Notice of variation with introductory note

Variation application number
EPR/PP3139GB/V008

Hafod Quarry Landfill

This variation of the environmental permit allows the operator to part replace the existing 3 steel leachate storage tanks with a single, partially below ground concrete tank, with associated delivery and connection pipework, all located within the current site boundary. One tank will be retained to act as a primary holding tank to facilitate pumping and managing silting.

Schedule 7 (site plan) to be amended to drawing shown below;

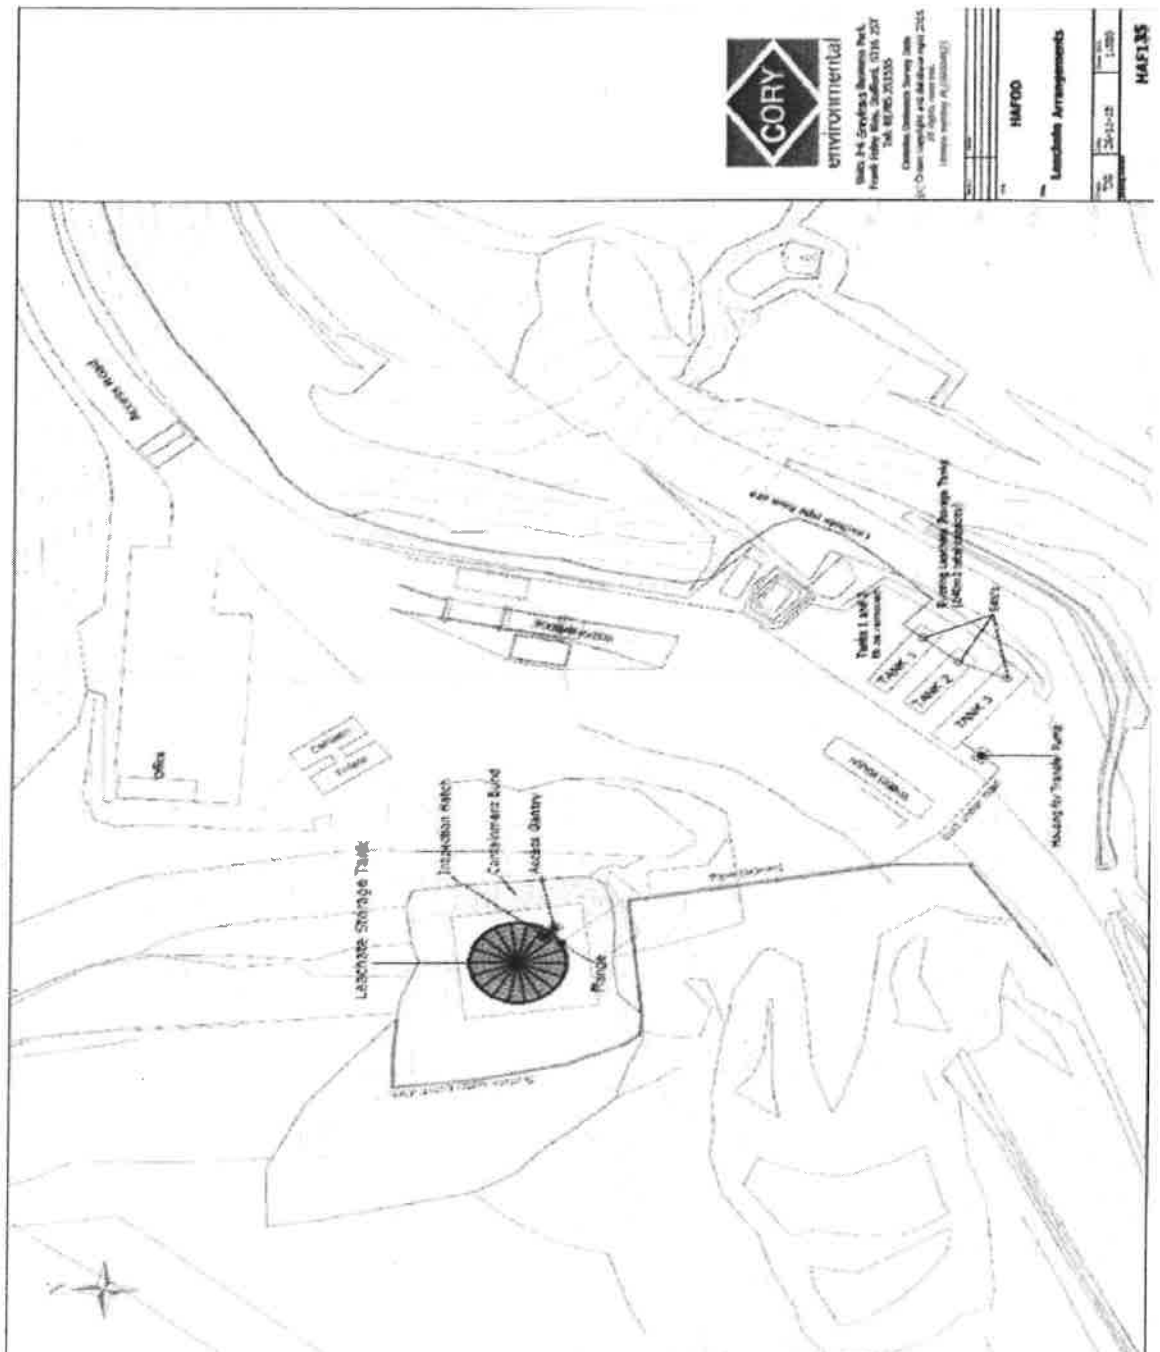
Tanks 1 & 2 (steel) to be removed, Tank 3 (steel) to be retained. Supplementary tank 4 (concrete) to be retained.
